### **ADDENDUM NO. 1**

### Durham BOE, Phase 2 Shoppes of Hope Valley Improvements

Date of Issue: May 16, 2025

2 BUILDING 2 - MECHANICAL ROOF PLAN - NEW WORK M301 SCALE: 3/32" = 1'-0"

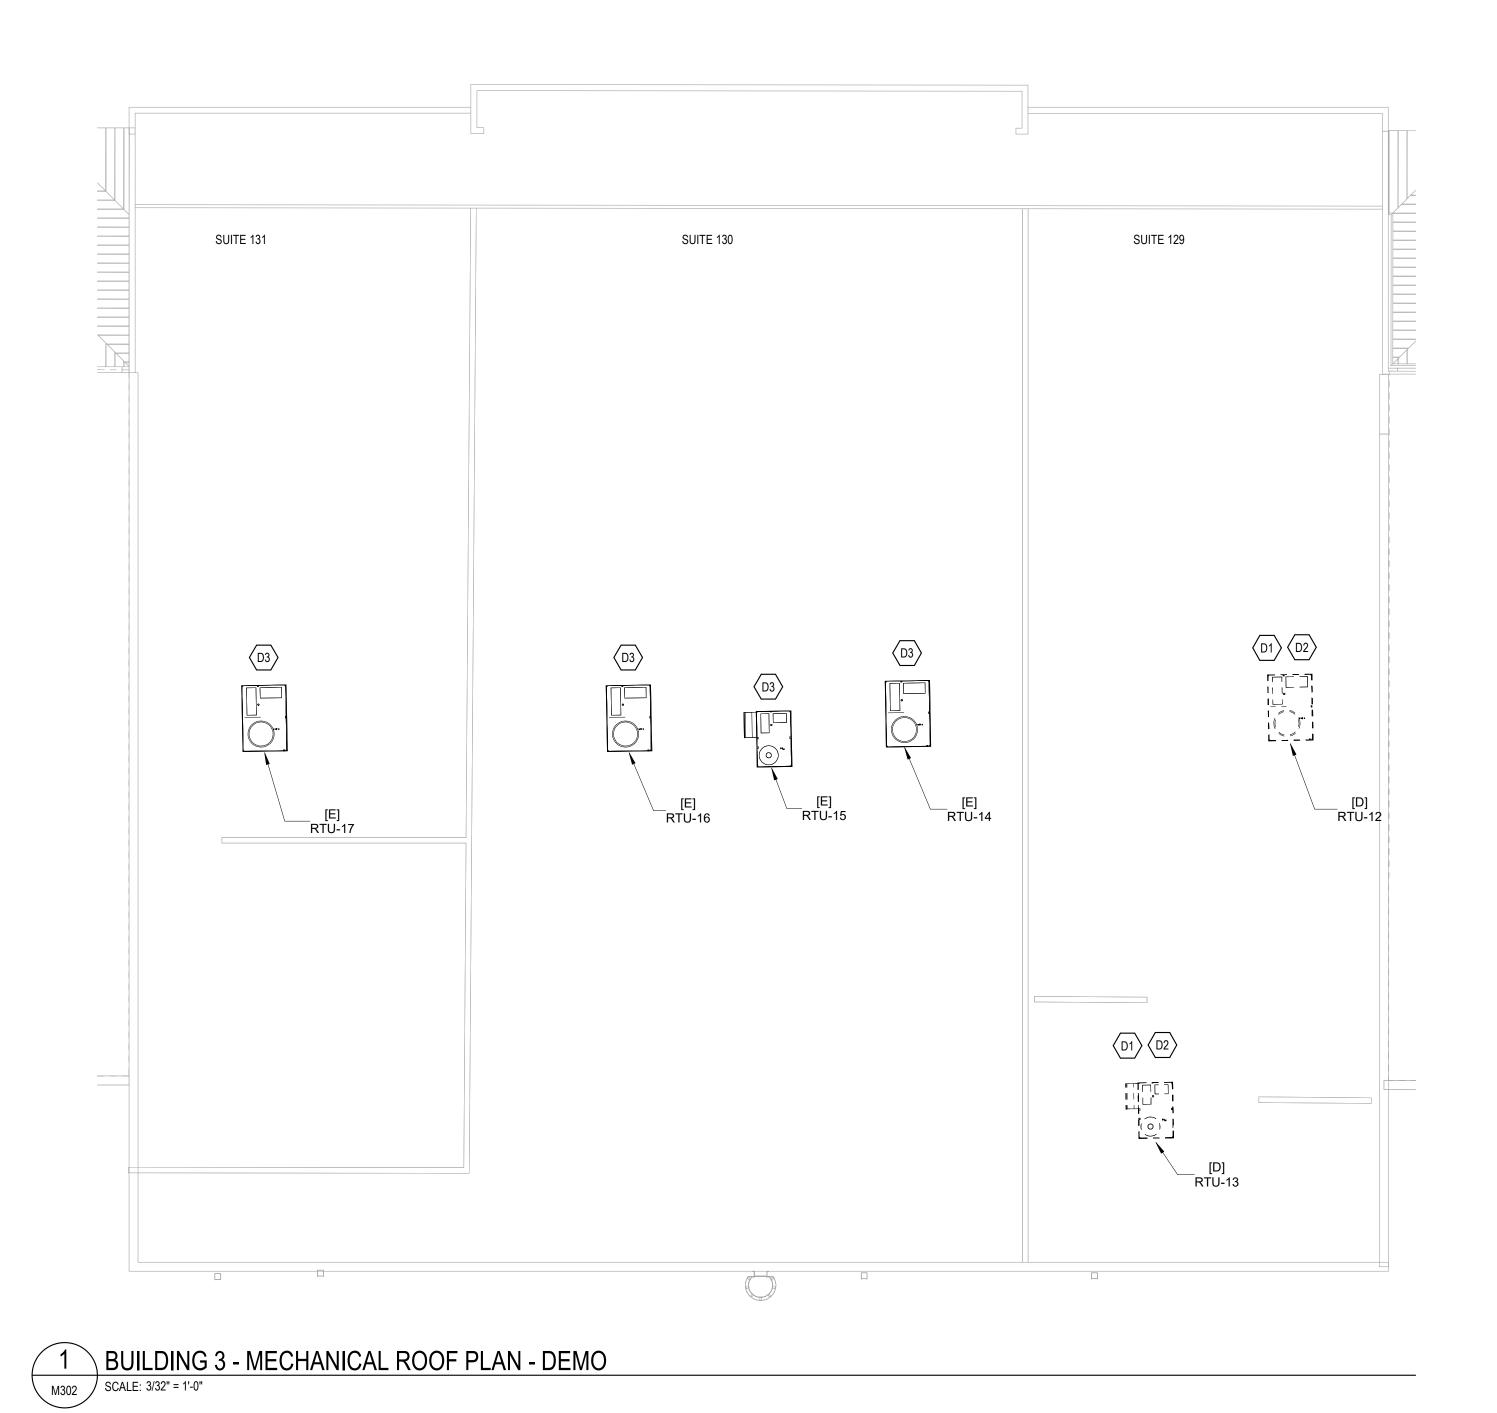
Comment: Note 2 on drawing M301 says to coordinate locations of rooftop units with Durham County and the architect. Is this applicable to this project since all units are replacements?

#### Drawing M301 – BUILIDING 2 MECHANICAL ROOF PLANS:

ROOFTOP UNIT DETAIL - BOTTOM TAKEOVER M601 SCALE: NOT TO SCALE

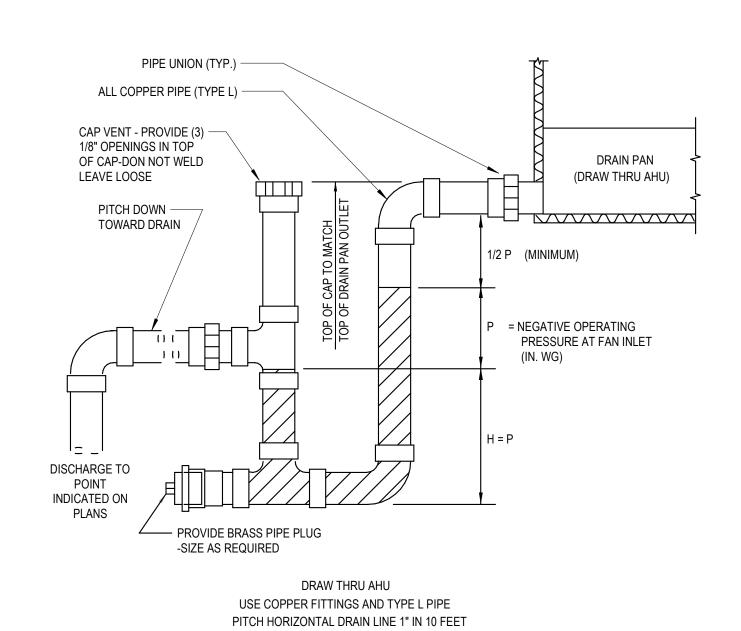
Comment: Mechanical Drawing M601 is showing the duct detector in the duct below the roof. During the walk thru we looked at one unit and saw no duct detector. Could have been for one or two reasons, unit not large enough and does not require a duct detector, or the duct detector is in the unit. How do we proceed with the bid package if the duct detectors are in the units?

#### Drawing 601 - MECHANICAL DETAILS:
